WARNING LETTER / REQUEST FOR INFOMATION

Inspections at Waimanalo Gulch Sanitary Landfill Solid Waste Management Permit No. LF-0054-02

INSPECTION REPORT

Photograph 3
Waimanalo Gulch Sanitary Landfill and Ash monofill 92-460 Farrington Highway, Kapolei

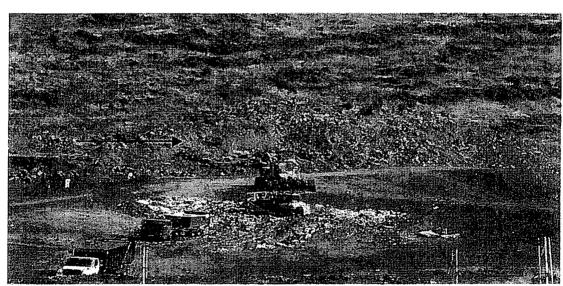
On May 16, 2008, the inspectors noted approximately 10 cubic yards of asphalt mixed with soil and concrete slabs on the top deck of ash monofill Cell 3 (see photograph 3). According to Justin Lottig, the material is to be used as wet weather material. On May 28, 2008, Mr. Whelan also stated that the material was to be used for wet weather material for the ash monofill area. The inspectors explained to Mr. Whelan that storing of asphalt material and concrete slabs mixed with soil on the top deck of the ash monofill is in violation of **Special Condition - Section D**, **Item 10**, which states: Stockpiled material within the landfill waste boundary shall be limited to cover material on the ash monofill. In addition, the SWS did not receive a written request for this operation, as required by **Special Condition - Section D**, **Item 11**.

On May 16, and May 28, 2008, the inspectors out briefed WMH on findings and potential violations related to the storage of asphalt and concrete slab and non-notification in violation of **Special Condition - Section D**, **Item 10**.

Please provide the volume of stockpiled material containing asphalt, concrete slab mixed with soil, the length of time the material has been stored at the ash monofill Cell-3, and schedule for removal/use of the material.

Photograph 4
Waimanalo Gulch Sanitary Landfill and Ash monofill

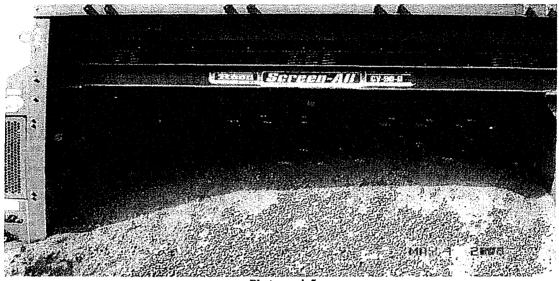
On May 9, 16, and 28, 2008, the inspectors noted large stockpiles of mixed boulders, rocks and fine-grained material on the top deck of MSW Cell 11 (see photographs 4, 6, 7, and 8). The stockpiles were of excavated material that was quarried during the construction of MSW Cell E-4, and were gradually created on top of MSW Cell 11 during the past year. **Special Condition - Section D, Item 10** limits the temporary storage of stockpiled material within the landfill to cover material, gravel for roads/wet weather, liner, etc.

The SWS did not receive a written request and did not approve the storage of the excavated material on top of MSW Cell 11 in violation of **Special Condition - Section D, Item 11**.

Based on our interviews with WMH staff, the material has been stored in excess of thirty (30) days and the schedule for removal was not provided. SWS staff did not observe any temporary berms or other measures to control stormwater flow in the vicinity of the storage piles. Approximately 50% of the storage piles included a significant quantity of fines and smaller graded material, which may direct surface water runoff from the piles. Approximately 50% of the storage piles included larger pieces of gravel and boulders, which would not shed water and may collect rainwater within the

In addition, the most recent topographic map, dated May 9, 2008, submitted to SWS as part of the Annual Operating Report, shows the stockpile of mixed boulders, rocks, and fine-grained material located at MSW Cell 11 at a height of 469.5 feet above mean sea level. The permitted final grades for the same area, where the stockpile is located, is at an elevation of 430 to 440 feet above sea level.

Please provide the approximate volume of excavated material stored at MSW Cell11, the length of time the material has been stored on site, and schedule for removal/use of the material.
